Re: Spruce Stret Project

AH-12 86-94 Spruce St REVISED 11.12.25.docx;

All, see attached for newly updated plans for 86-94 Spruce.

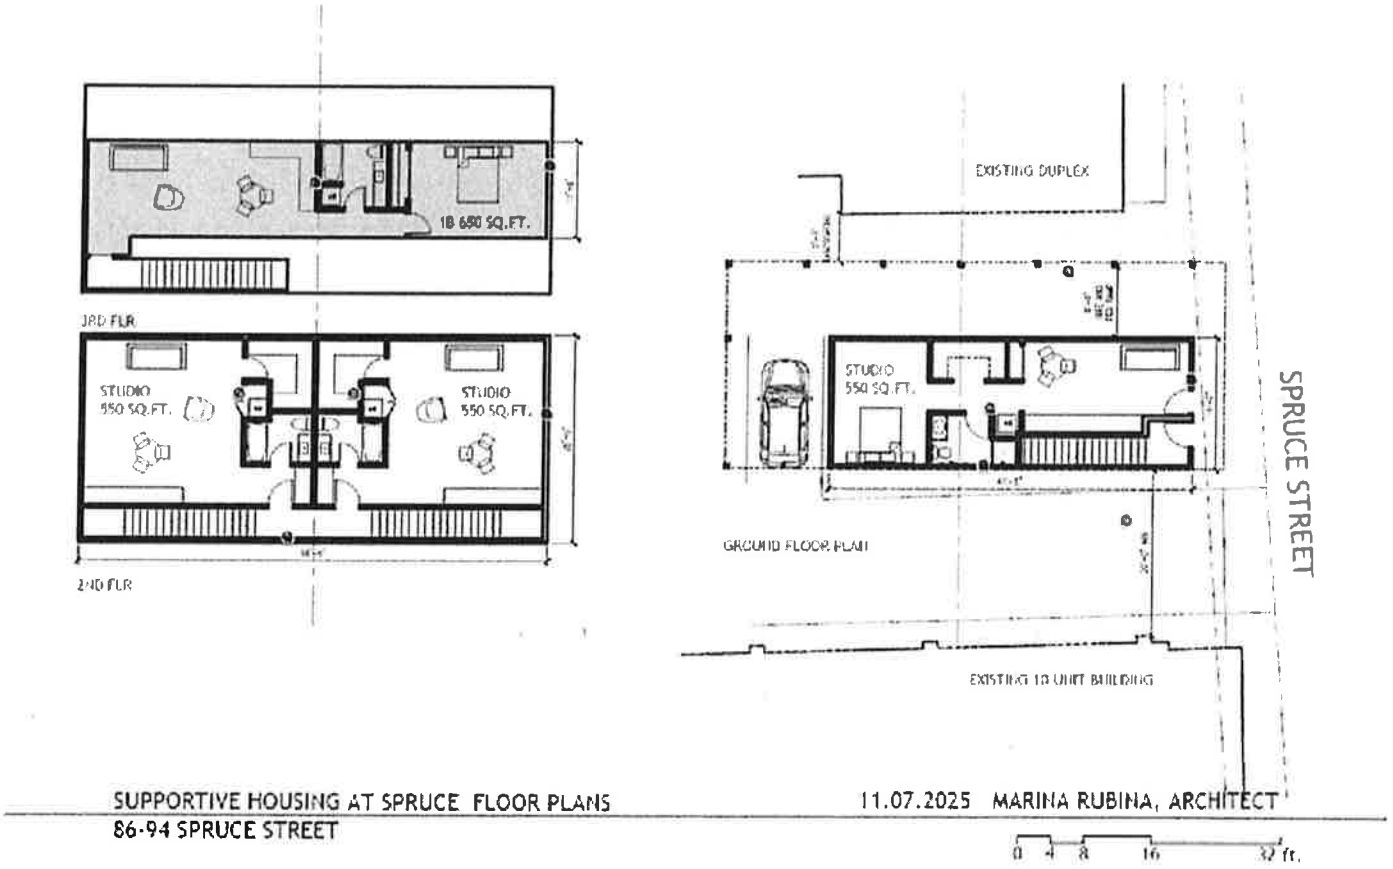
I don't see two front doors here and can't see why it would be needed. I remember them mentioning a porch — which we said was important to maintain the residential streetscape feel. Looks like dead space but hard to tell. Why don't you write to Daniel directly and ask for clarification?

When they showed us the massing of the street frontage facing Spruce at the meeting on Friday, this structure definitely has a pitched roof. Thus I think the first possibility you mention (dead attic space under the eaves) is definitely the explanation. Two front doors is not so bad given that there are a lot of duplexes in this neighborhood, but I take your point. We should ask to see more than massing next time, with at least openings shown, so we can consider the question properly.

Do you have an understanding of what is proposed in the new building fronting Spruce Street in the attached drawing, particularly on the third floor? Do you read the white space as dead space in a pitched roof or is it more of a penthouse-like cube in the center of that roof with a stair tower leading to it?

I know the initial thought was that this building would be a single-family home like the others on the street - or at least look like one - but it is looking less and less like that (two front doors, no porch, the overhang, the third floor, the inevitable architecture).
